**NIJ Standard 0101.07, *Ballistic Resistance of Body Armor*
Addendum 1**

October 31, 2024

This addendum includes revisions to NIJ Standard 0101.07, *Ballistic Resistance of Body Armor*. Users of the NIJ Standard should incorporate the revisions in this addendum as a part of the NIJ Standard.

Figure 8. NIJ RF1, NIJ RF2, and NIJ RF3: Example of Shot Placement for 3 Shots per Test Item on a Multi-Curve Plate

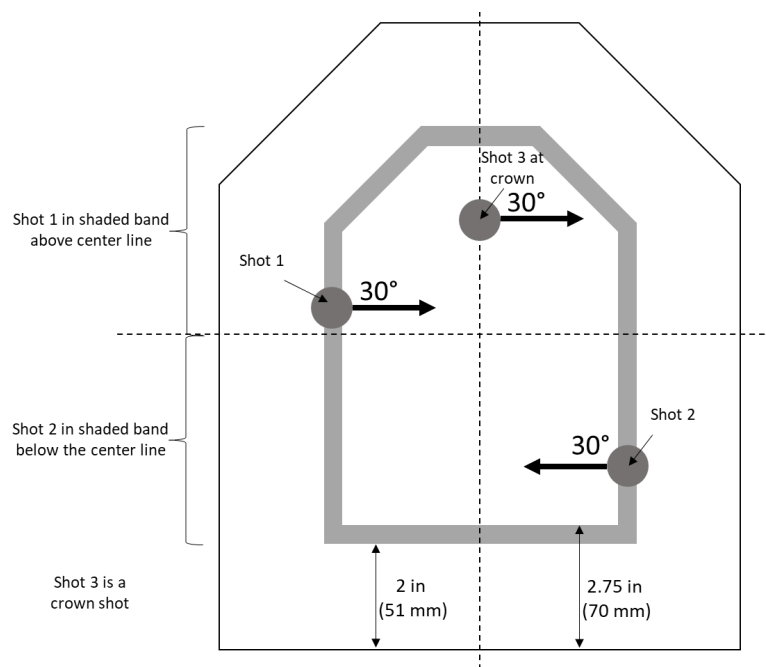
Revision: Figure 8 is modified to show the shot on the left in the band pointing 30 degrees inward toward the center rather than 30 degrees outward toward the edge.

- 12.2.2.4. For a 3-shot plate with 30-degree shots, refer to Figure 8. The following requirements apply:

- (1) The crown shot and the next closest shot shall be angled **parallel to** each other.
(2) The **shots in the shaded band** shall be angled toward the centerline.
